Amendment Application for the Proposed Kokerboom 1 Wind Energy Facility in the Northern Cape Province

Final Amendment Report

Date: April 2019

DEA Ref:14/12/16/3/3/2/985

Figure 2: Proposed optimised (amended) layout for Kokerboom 1 Wind Farm and associated infrastructure superimposed over mapped environmental sensitivities

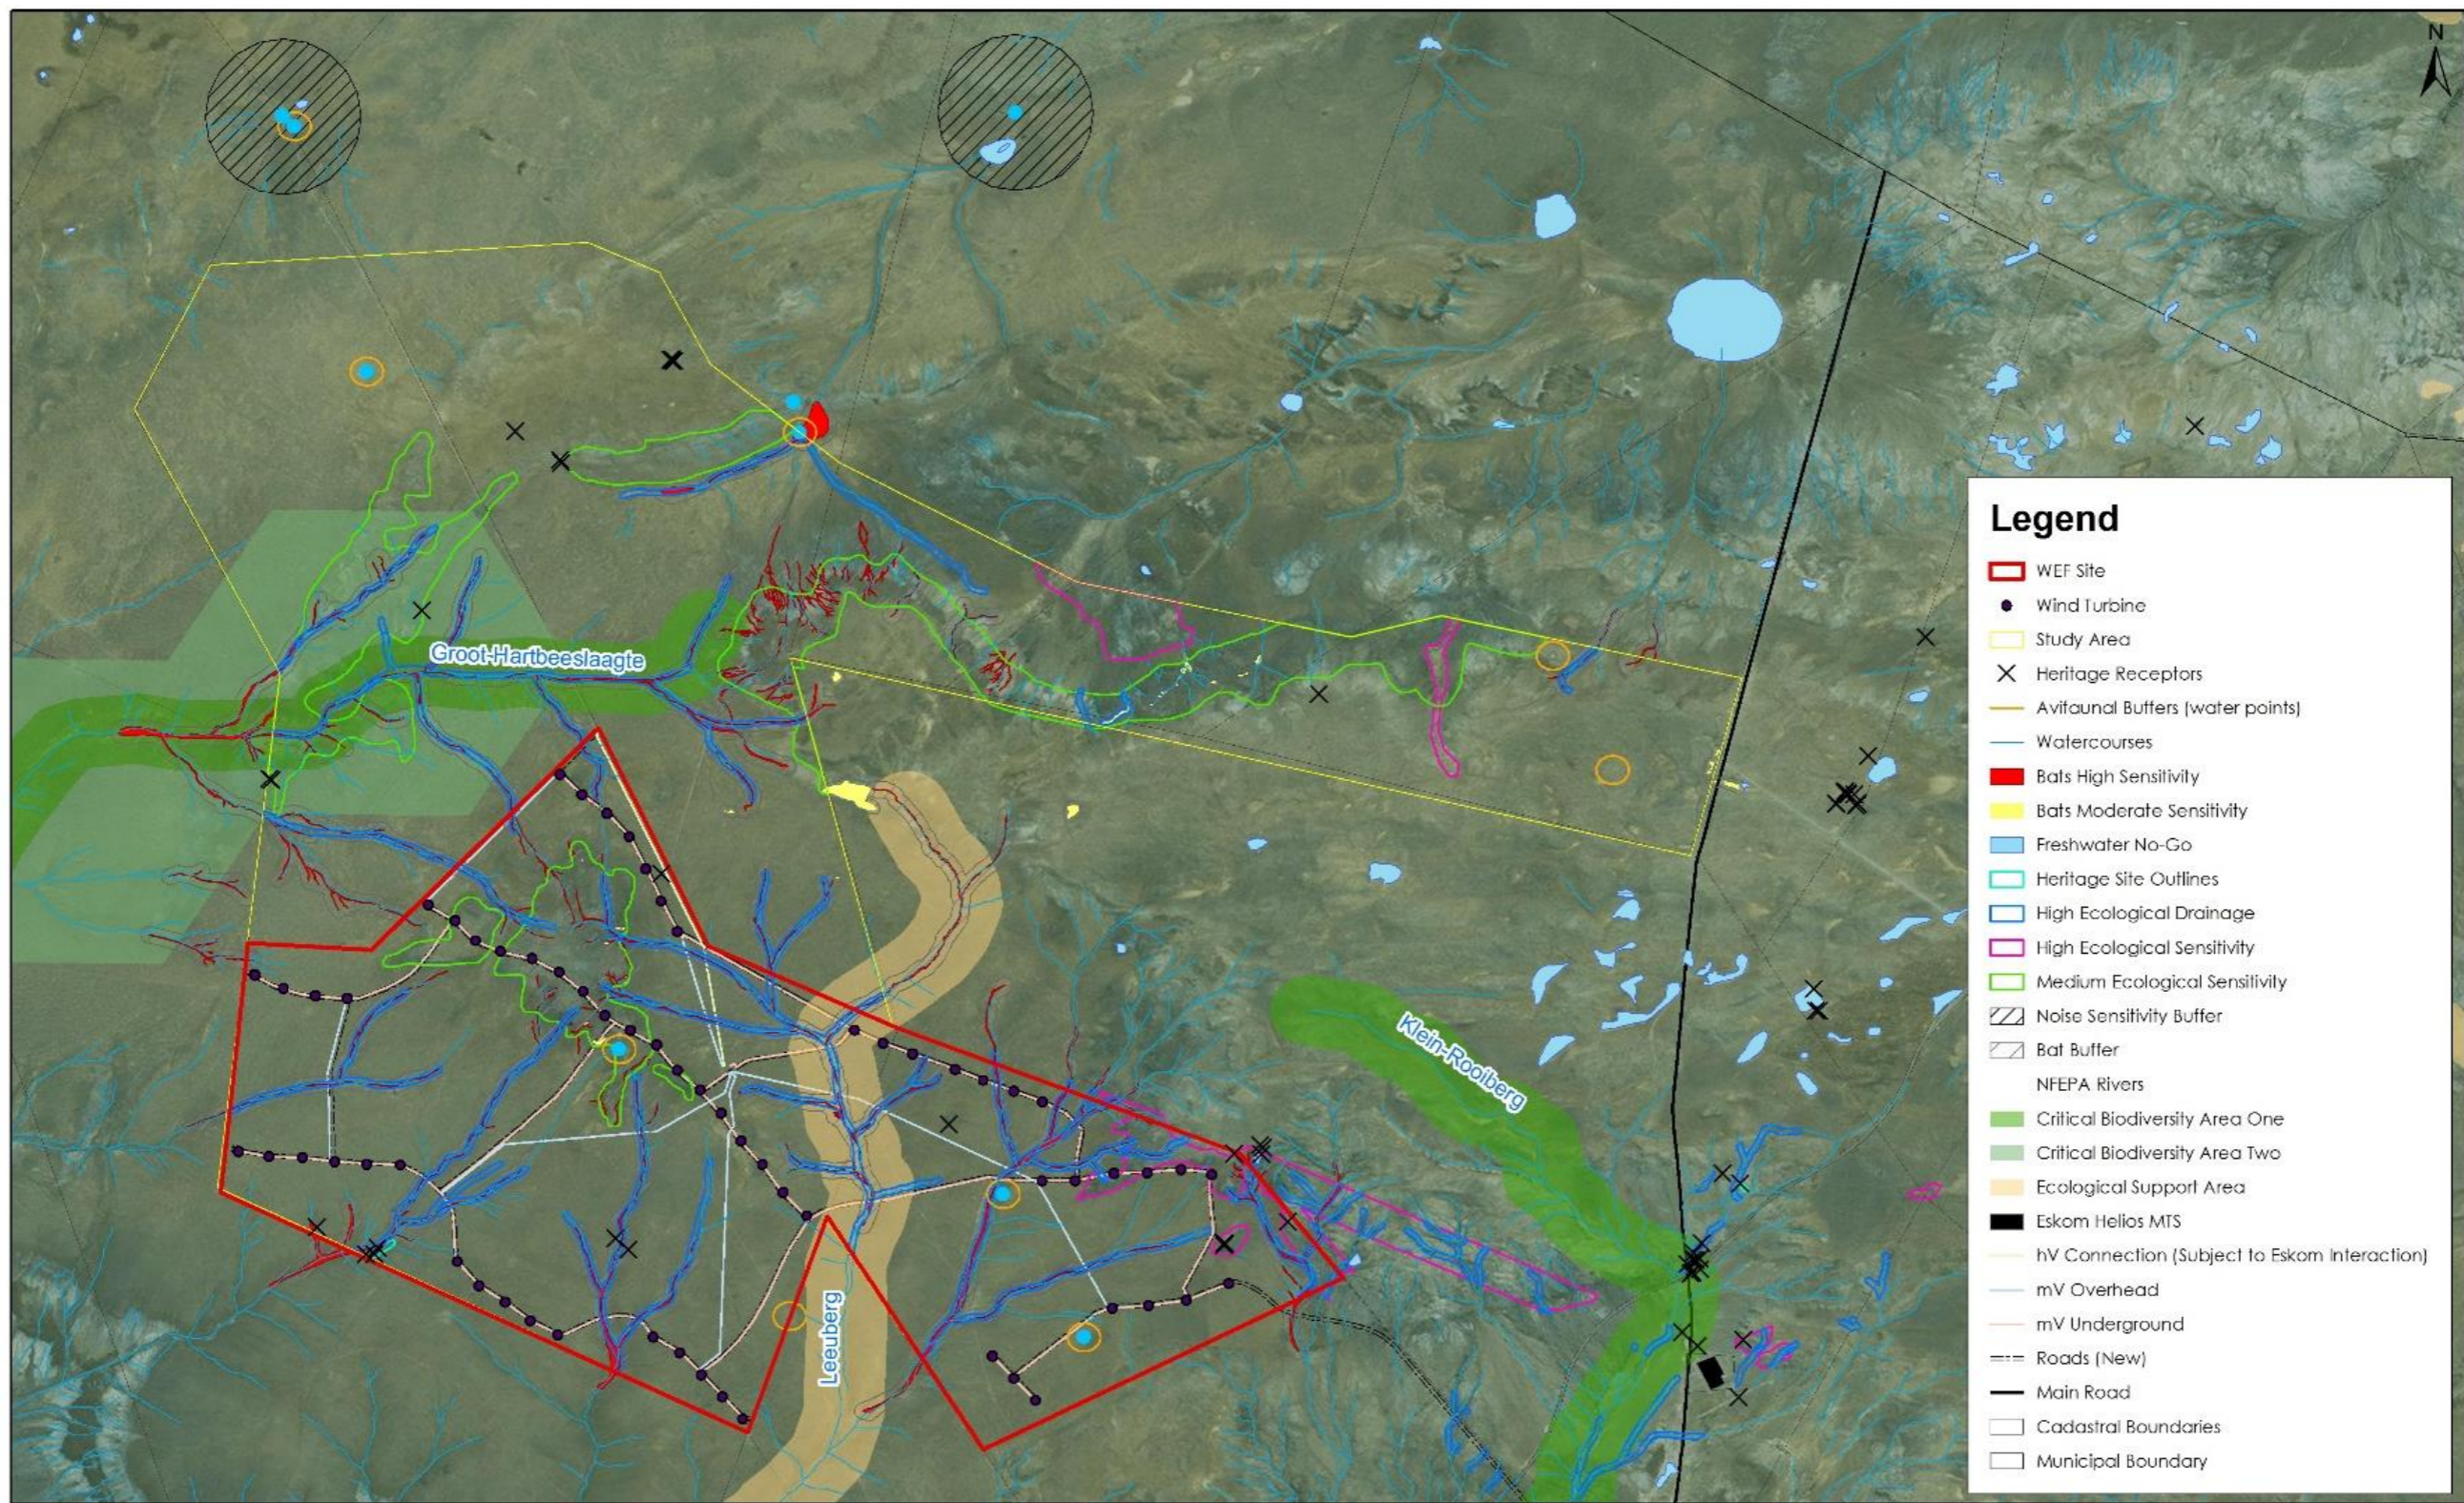
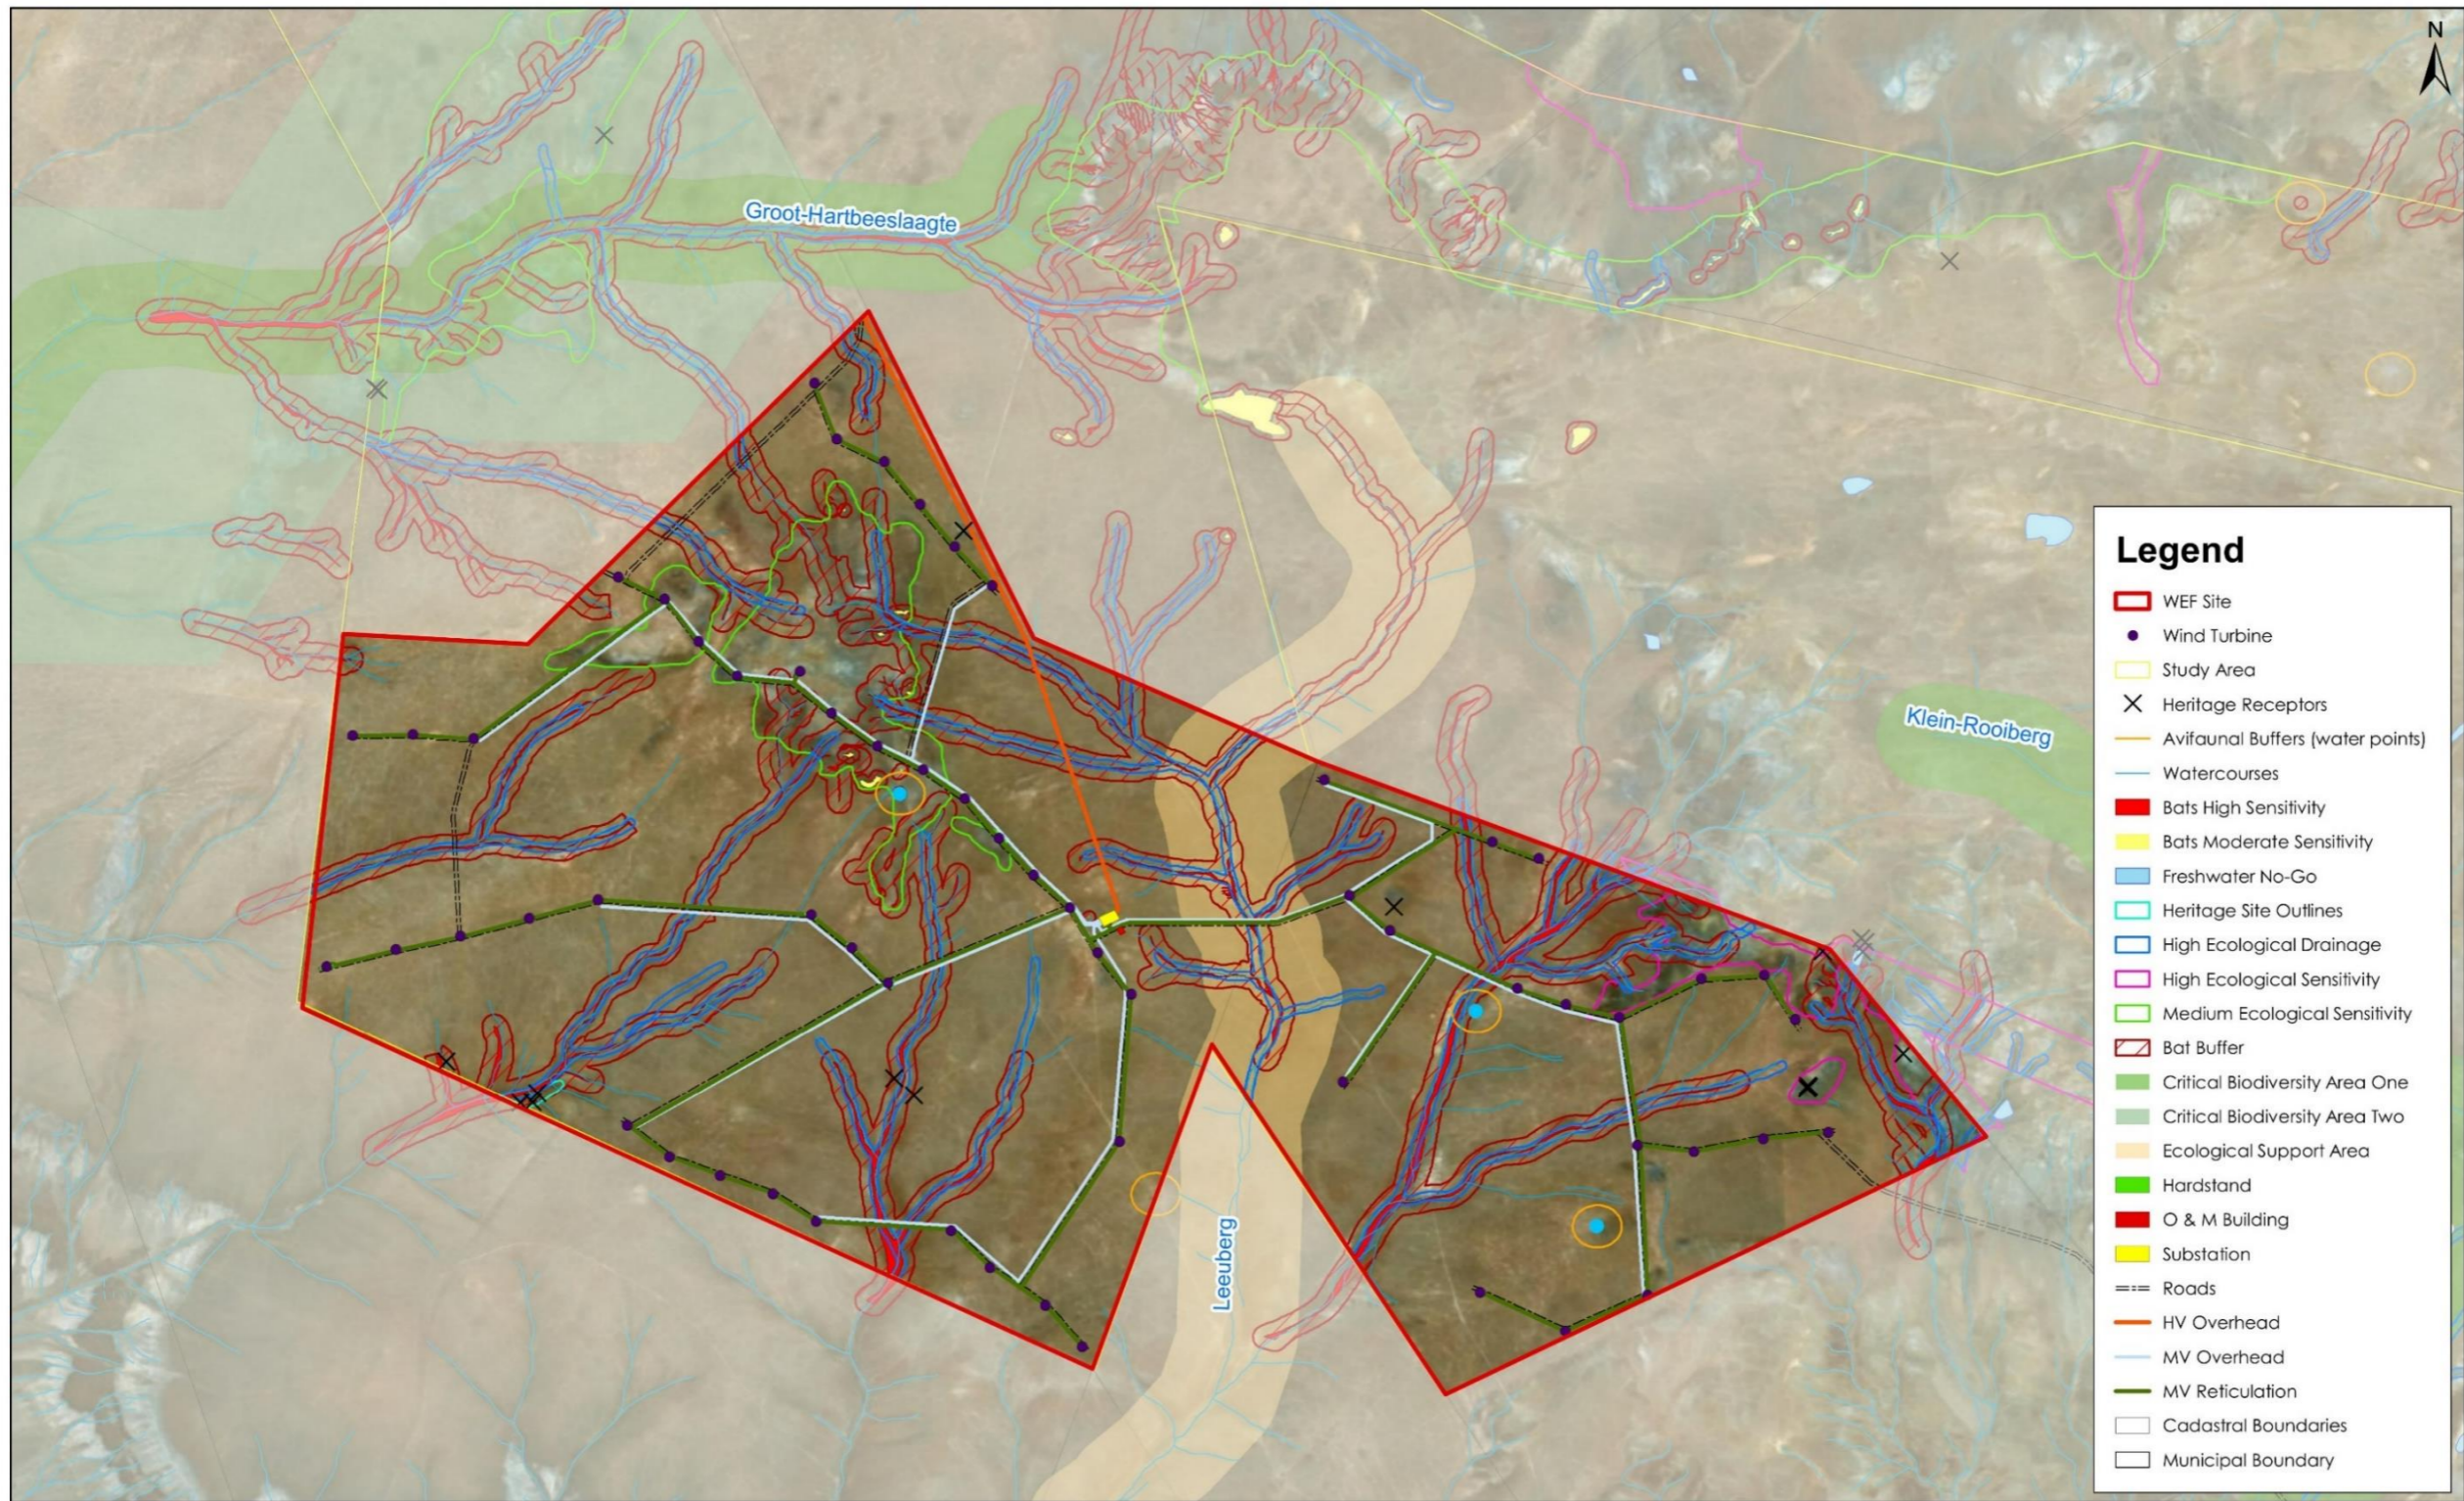
Business Venture Investments No 1788 (Pty) Ltd, is applying for an amendment that would allow for increased hub height, rotor diameter, the power generation capacity of the turbines and larger foundation areas. As a result, the Kokerboom 1 Wind Farm layout would need to be re-designed/ re-optimised in response to the revised turbine specifications, while taking into account environmental sensitivities (Figure 2). Table 3 below provides describes the amendments required to the authorised project specifications and scope.

In order to cater for the larger turbine specifications, it is necessary to revise the site layout plan to provide sufficient spacing between the larger turbines, for safety reasons and to reduce internal wake effects between turbines. The balance-of-plant infrastructure (i.e. internal roads, cables, substation, hard stands etc.) has been revised and optimised in order to cater for the revised turbine positions. The revised turbine locations and associated balance-of-plant infrastructure are all located within the footprint that was previously assessed in the original EIA.

In addition, a length of overhead high voltage (HV) powerline is required to link the wind farm's substation to the Eskom switching station (the latter forms part of a separate EA) in order to export the electricity generated by the wind farm. Due to the costs associated with the HV powerline, the most direct route between the substation and switching station has been proposed, to minimise the length of the powerline. Keeping the length of the HV line as short as possible is considered desirable to minimise potential avifaunal impacts. As a result, the proposed overhead HV routing deviates from the internal road network.⁴

⁴ This length of overhead HV powerline was assessed in the original EIA and forms part of the site layout plan that was submitted to DEA with the final EIA Report (Figure 1). However, Condition 58 of the EA stipulates that all cables must follow internal roads. It is now requested that this condition be amended (see Table 4) in order to allow for the overhead HV powerline to deviate from the road network and follow a more direct route to the new onsite substation location as shown in Figure 2.

Area occupied by substations	Approximately 14,400m ² .	No amendment required.
Location of substation	30°27'36.92"S 19°26'1.58"E	A new location is proposed approximately 850m southeast of the authorised substation location (30°28'6.42"S 19°26'15.88"E).
Area occupied by both permanent and	Total: approximately 114,100 m ² .	Total: approximately 109,100 m ² .
